ANOINTED FUTURE TOO
DAYCARE

5842 HICKORY GROVE RD.
CHARLOTTE, NORTH CAROLINA

C0100

SUBJECT: Administrative Approval for Petition No. 2009-001 Janice White

1 SITE PLAN WITH REVISE CHANGES

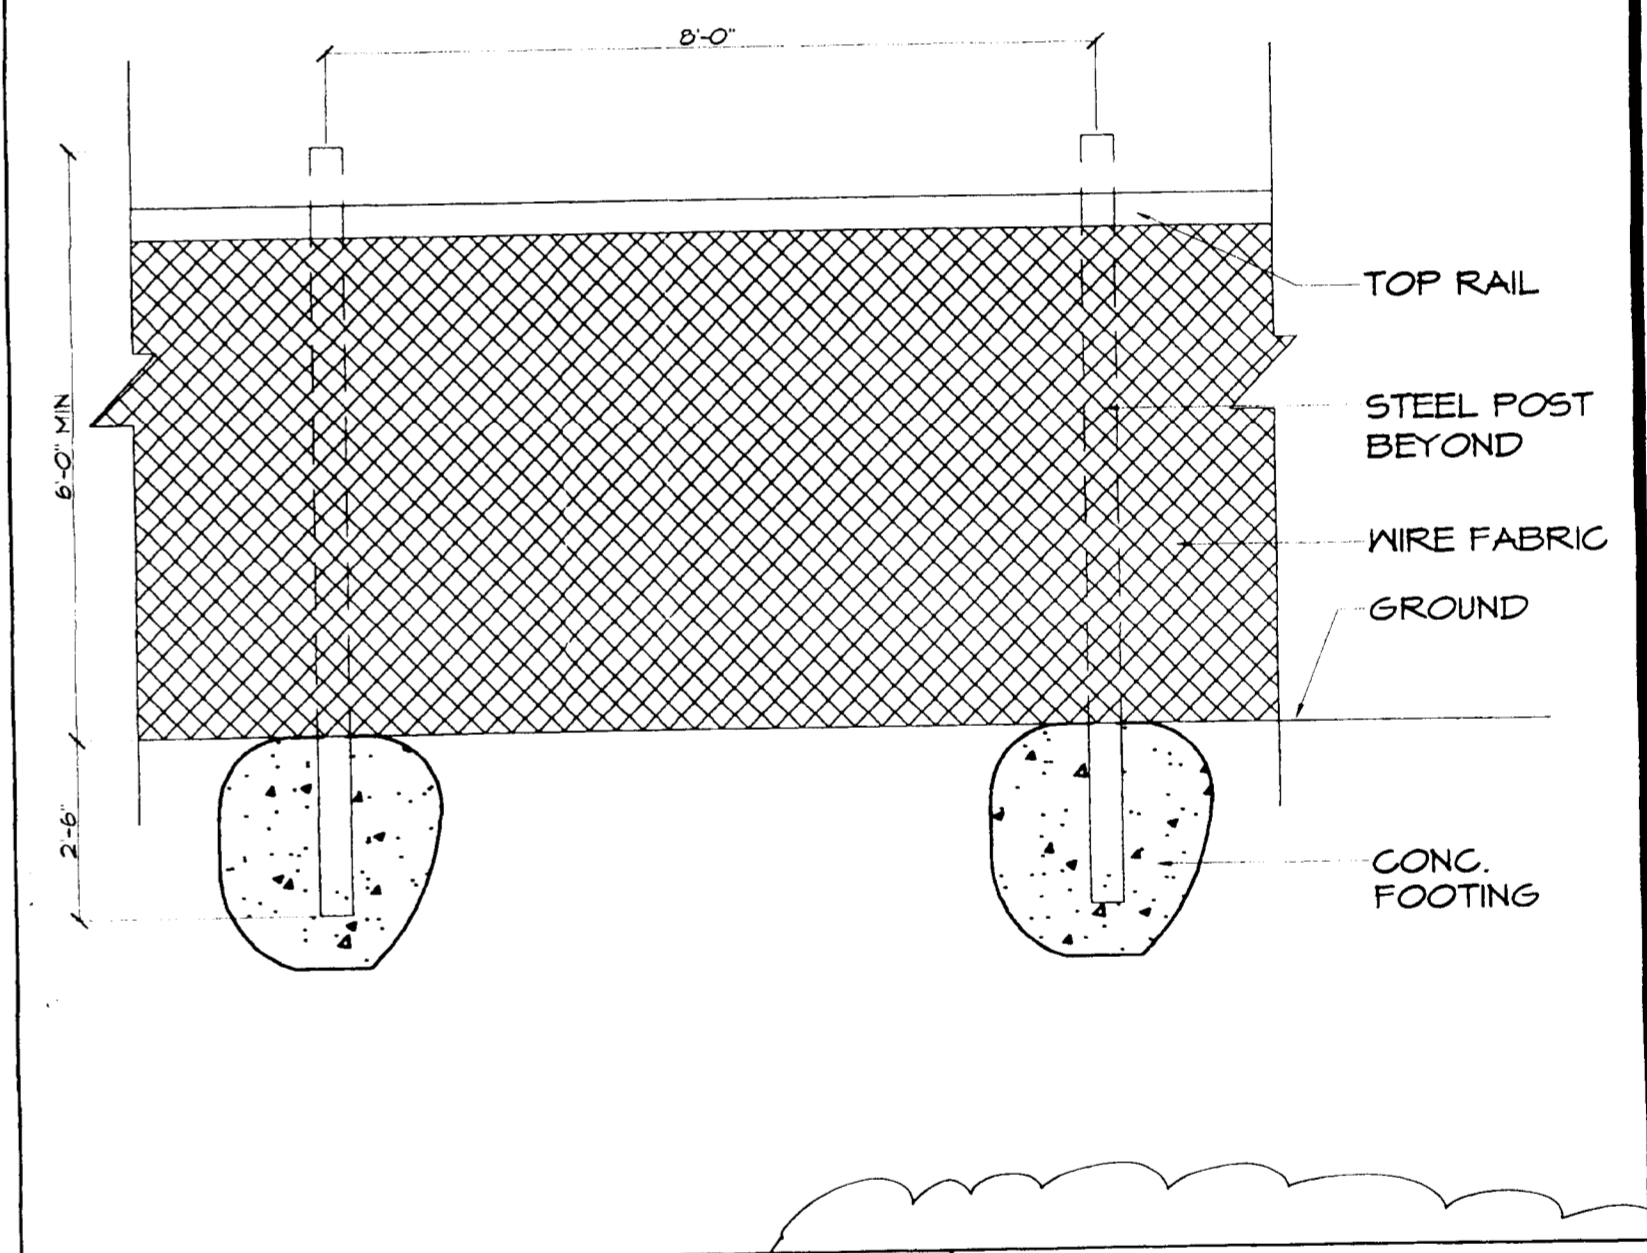
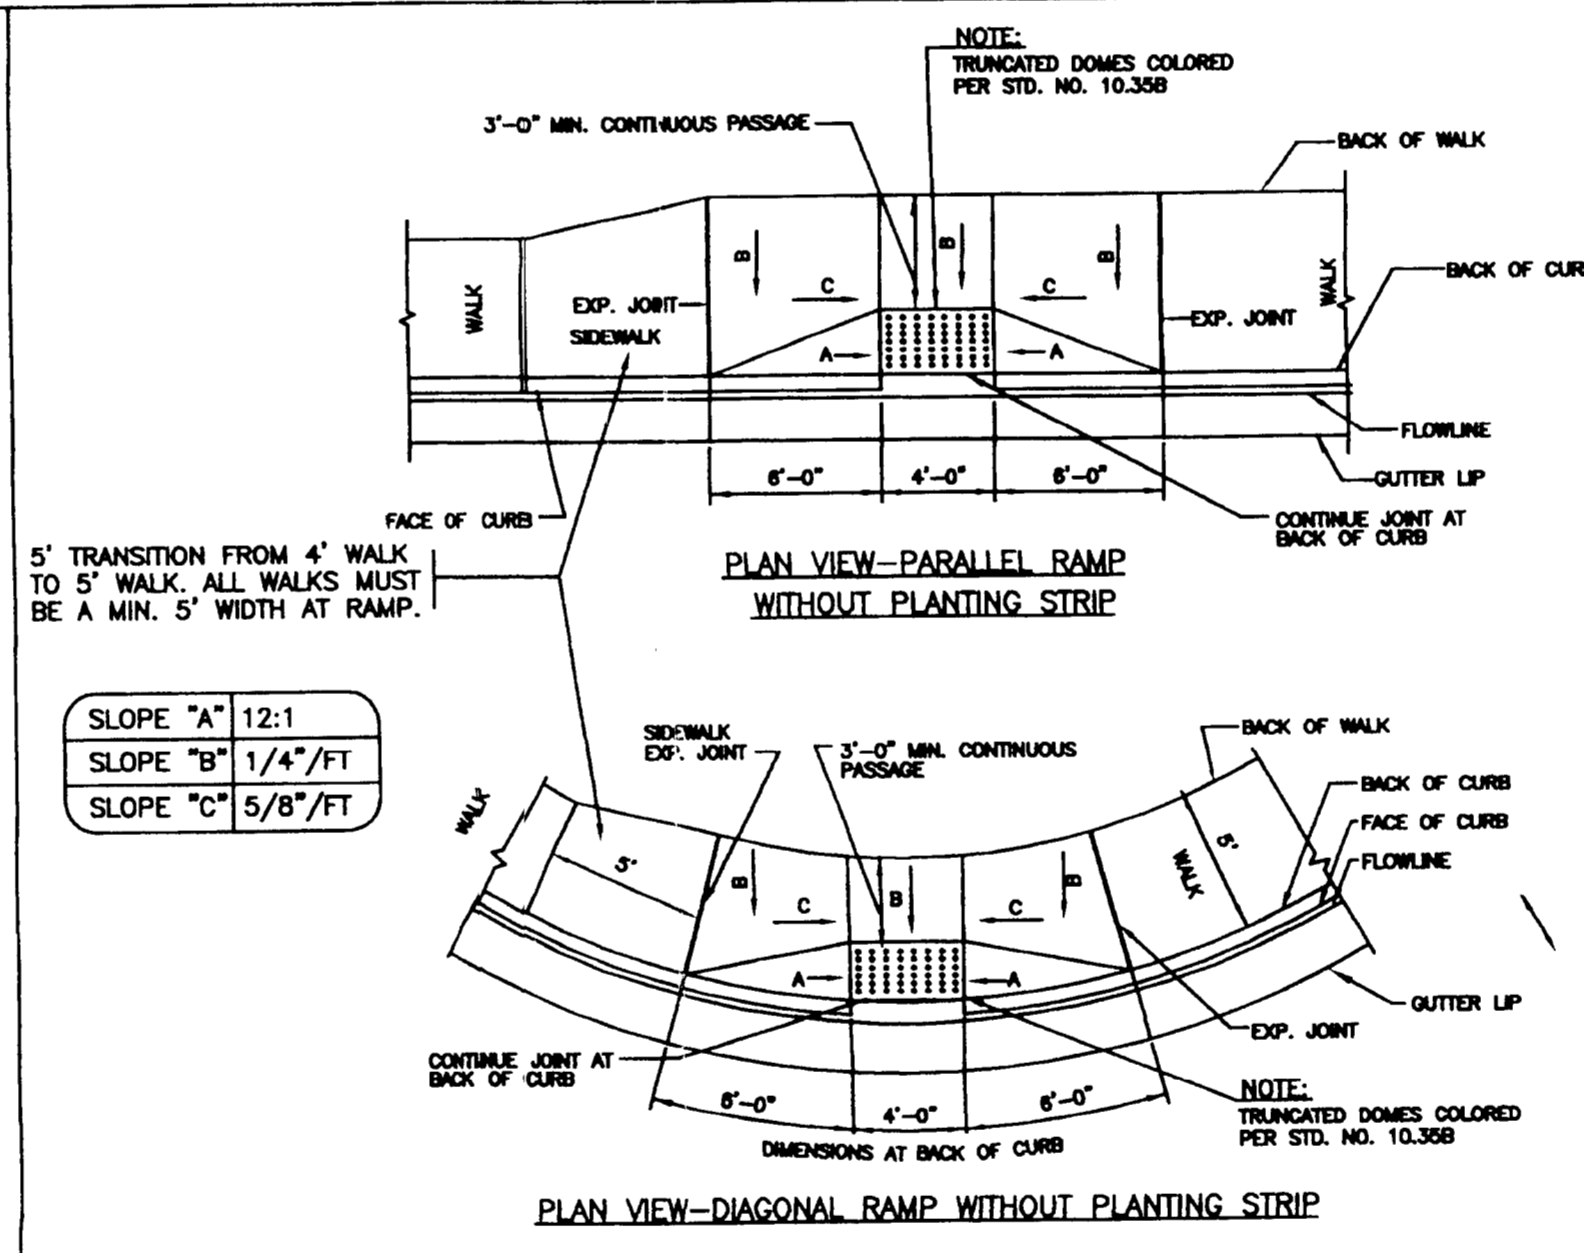
Attached is a revised site plan for the above referenced rezoning petition. The site plan attached allows for a modification of the site to account for the 25% buffer reduction using a fence. Also the plan allows for modification of parking for the site. Since this change does not alter the intent of the development and meets the requirements of the Charlotte Zoning Ordinance Section 6.207 Alterations to Approval, minor changes, I am administratively approving this plan. Please use these plans when evaluating requests for building permits and certificates of occupancy.
